Re: Consolidated Edison Company of New York, Inc.
(Indian Point Station, Unit No. 2)
Docket No. 50-247

ATTACHMENT A

Technical Specification
Page Revisions

APPLICATION FOR AMENDMENT TO
OPERATING LICENSE

Figure 3.1 Facility Management and Technical Support Organization

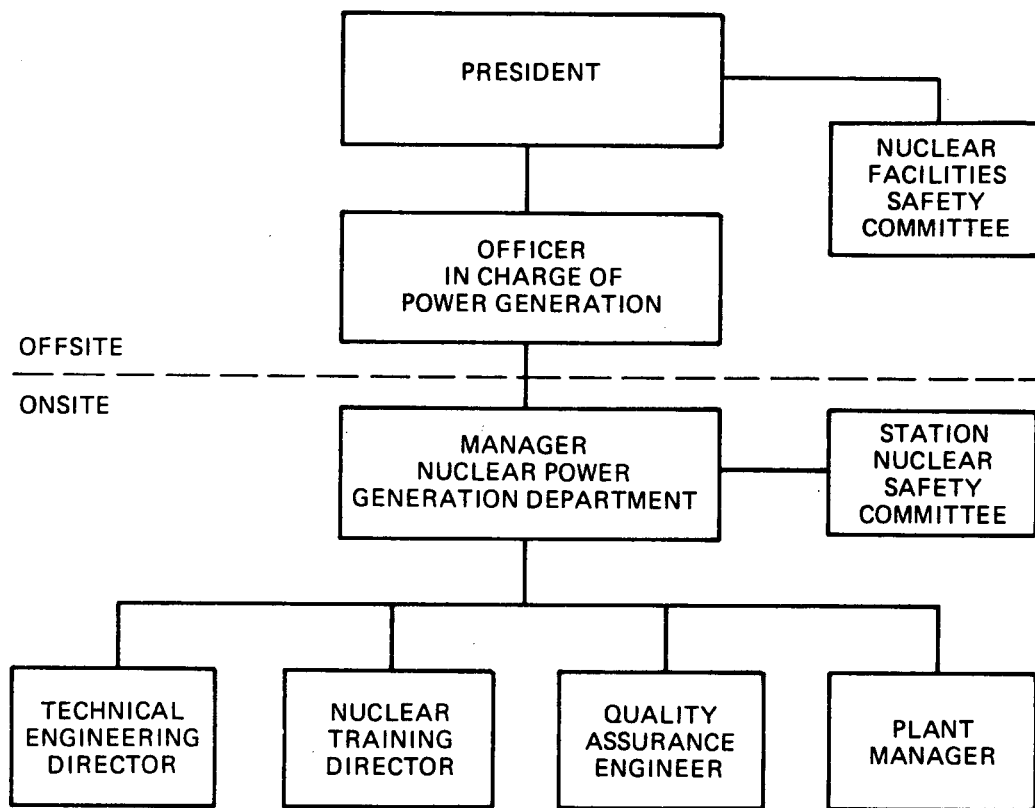
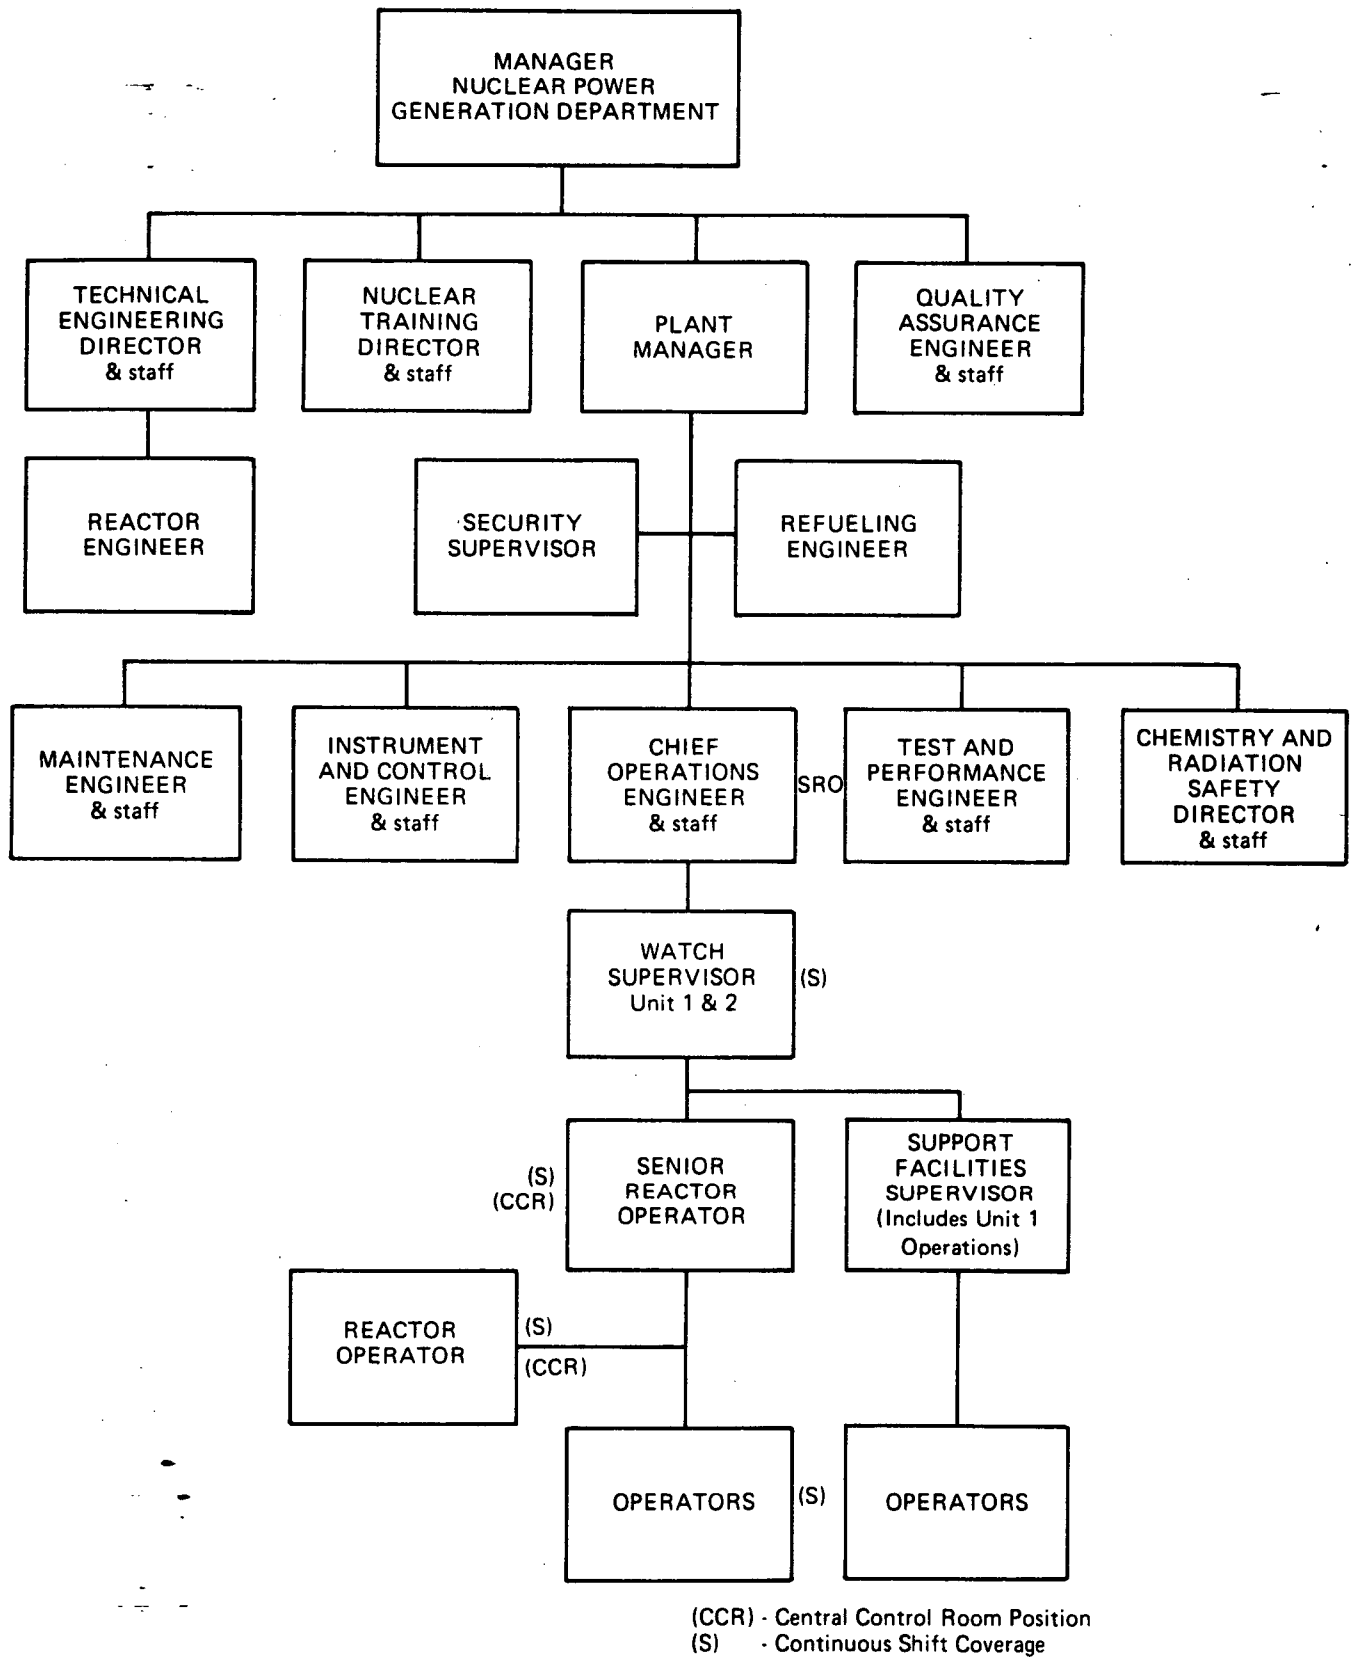
The proposed technical specification revisions, contained in Attachment A to this Application, would effect certain administrative and editorial changes. The proposed revisions to section 3.1 would require that: (a) the Department Manager rather than the Plant Manager be responsible for overall Unit No. 1 facility operation, (b) the Station Nuclear Safety Committee report to the Department Manager rather than the Plant Manager, and (c) the Nuclear Facilities Safety Committee report to and advise the President of the Company rather than the Senior Company Officer in Charge of Power Supply. The revised Figures 3.1 and 3.2 would reflect these and additional pending organizational changes.

3.1.1 The organization for facility management and technical support shall be as shown in Figure 3.1.

3.1.2 The Facility Organization shall be as shown in Figure 3.2. The Support Facilities Supervisor is responsible for operations at the Unit No. 1 facility.

Figure 6.2-1 Facility Management and Technical Support Organization

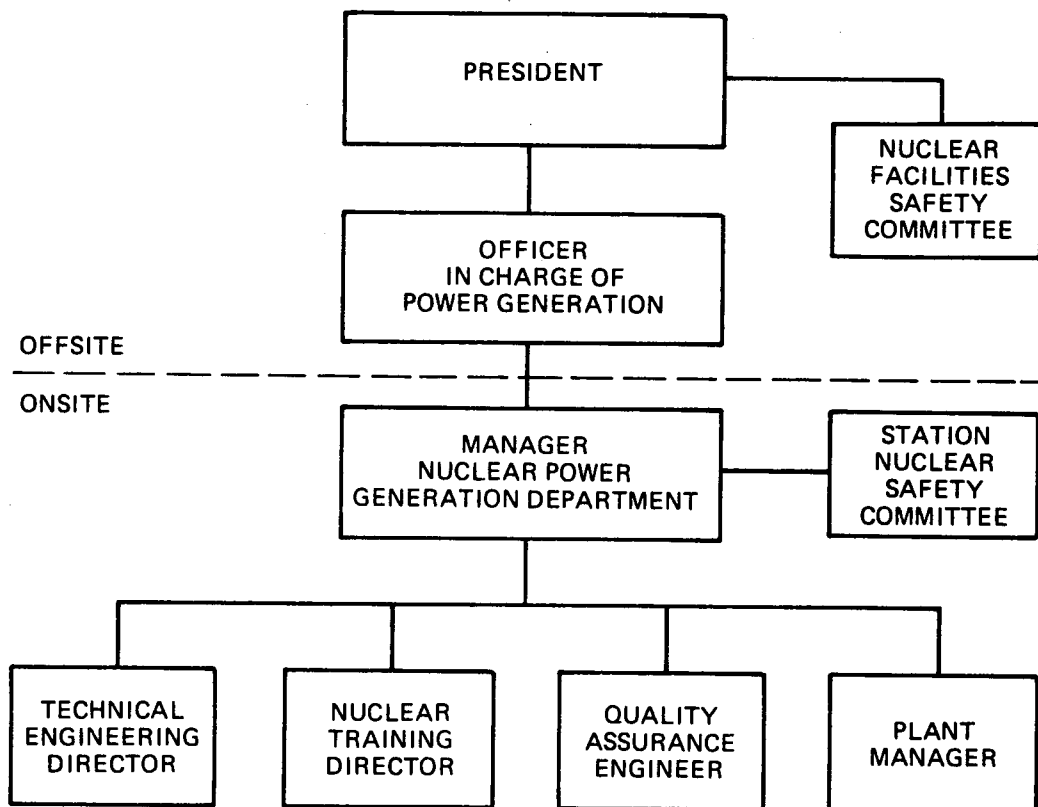
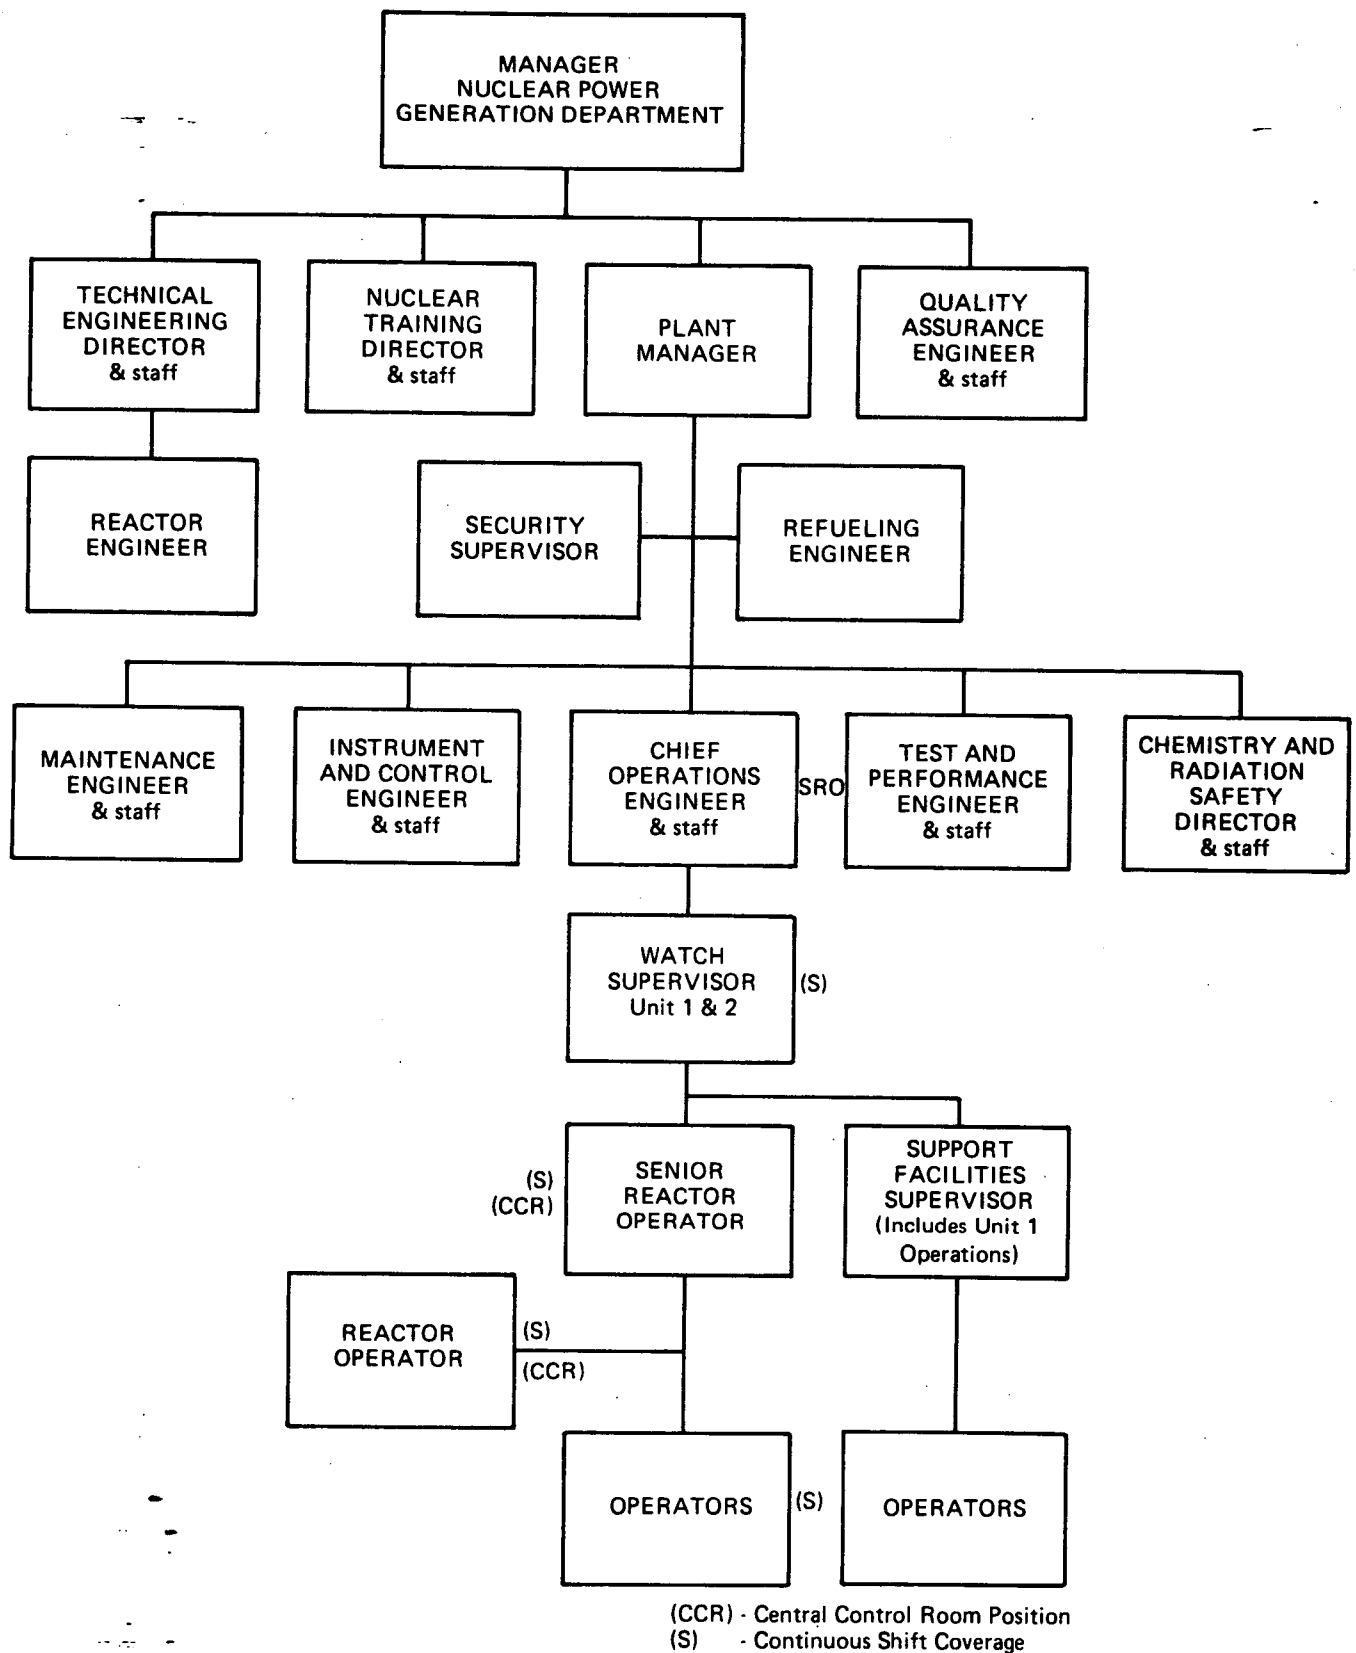
The proposed technical specification revisions, contained in Attachment A to this Application, would effect certain administrative and editorial changes. The proposed revisions to sections 3.1, 6.1, 6.2 and 6.5 would require that: (a) the Department Manager rather than the Plant Manager be responsible for overall Unit No. 2 facility operation, (b) the Station Nuclear Safety Committee report to the Department Manager rather than the Plant Manager, and (c) the Nuclear Facilities Safety Committee report to and advise the President of the Company rather than the Senior Company Officer in Charge of Power Supply. The revised Figures 6.2-1 and 6.2-2 would reflect these and additional pending organizational changes. The proposed changes to section 6.9.1 would clarify the reporting requirement that major safety-related corrective maintenance be included in the monthly operating reports.

6.2.1 The organization for facility management and technical support shall be as shown on Figure 6.2-1.

6.2.2 The Facility organization shall be as shown on Figure 6.2-2 and:
